# Common-mode return loss limits

P802.3ck D3.0 comments 178 181

Piers Dawe, Nvidia

January 2022

# Ineffective above 7.5 GHz

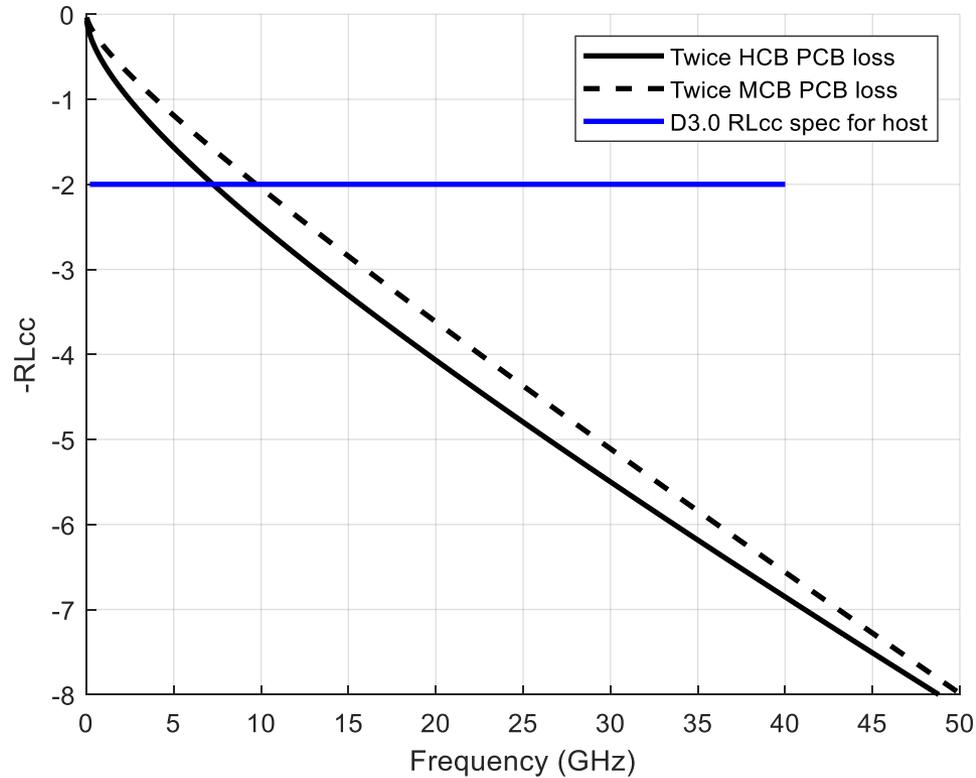
- We have common-mode return loss specs to ensure that any common-mode signal can dissipate
- Multiple places
- The limits  $\sim 2$  dB are extremely weak
- A 2 dB limit is ineffective above the frequency where the test fixture PCB loss is 1 dB
  - It acts as an indication that very bad common-mode return loss is not desired, but it does not impose an actual limit

# Mated test fixture RLcc for reference

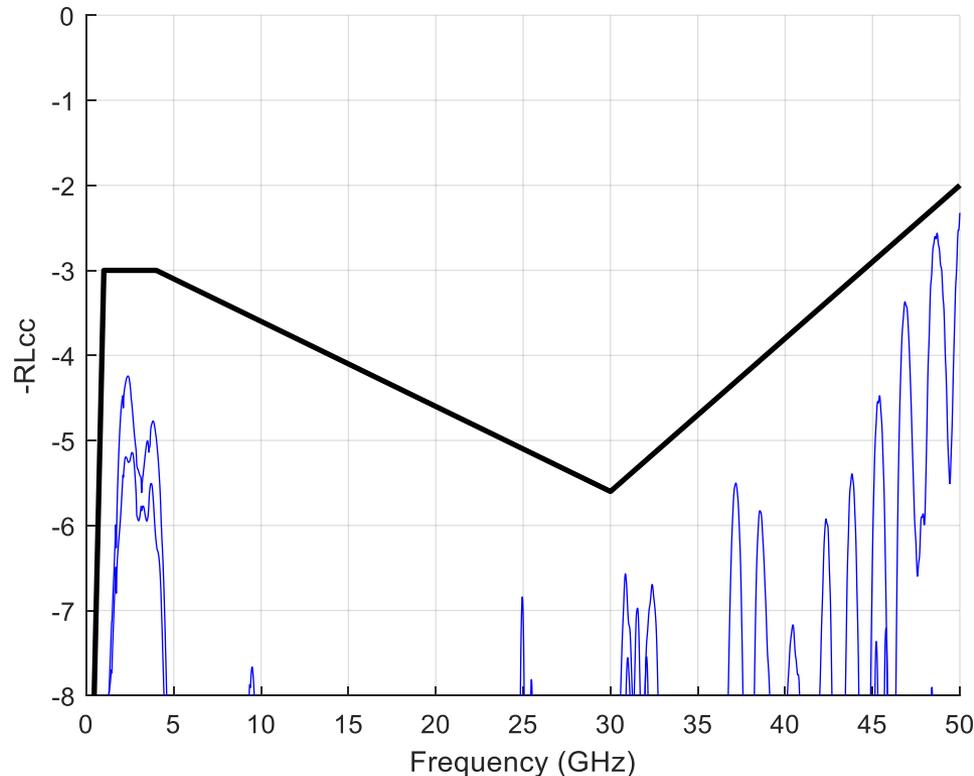
- As for the mated test fixtures and the cable, this common mode return loss spec RLcc becomes useless at the frequency when the MCB loss is 2/2 dB, which is only **10** GHz. The spec should trend down with the MCB trace loss at 0.1 dB/GHz
- Use a frequency-dependent mask
  - 2 dB  $0.2 \leq f \leq 4$
  - $1.6 + 0.1 * f$  dB  $4 < f \leq 30$
  - $8.5 - 0.13f$   $30 < f \leq 40$
  - $f$  is in GHz
- *It's worse than I said: 10 GHz should have been 7.25 GHz*

# Two mated compliance board pairs as surrogate for cable

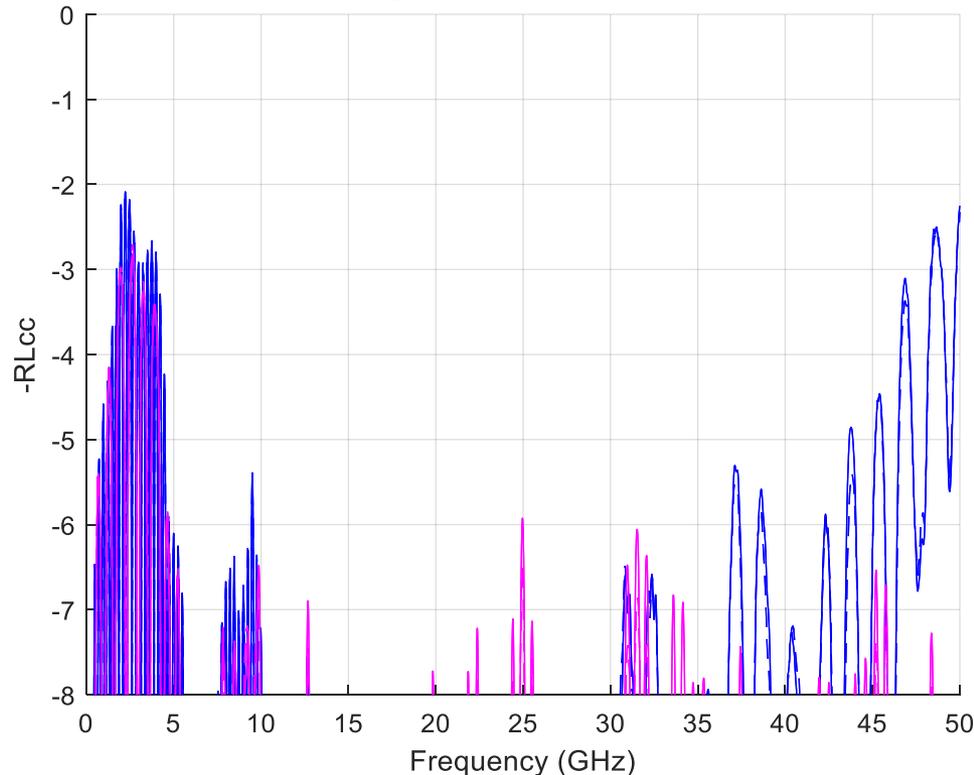
The cable RLcc is a little different

- At the lowest frequencies, the measurement can "see" both ends of the cable
- So the spec has to be relaxed at those frequencies
- 1.2 dB  $0.05 \leq f \leq 4$
- $0.76 + 0.11f$  dB  $4 < f \leq 30$  GHz
- $f$  is in GHz
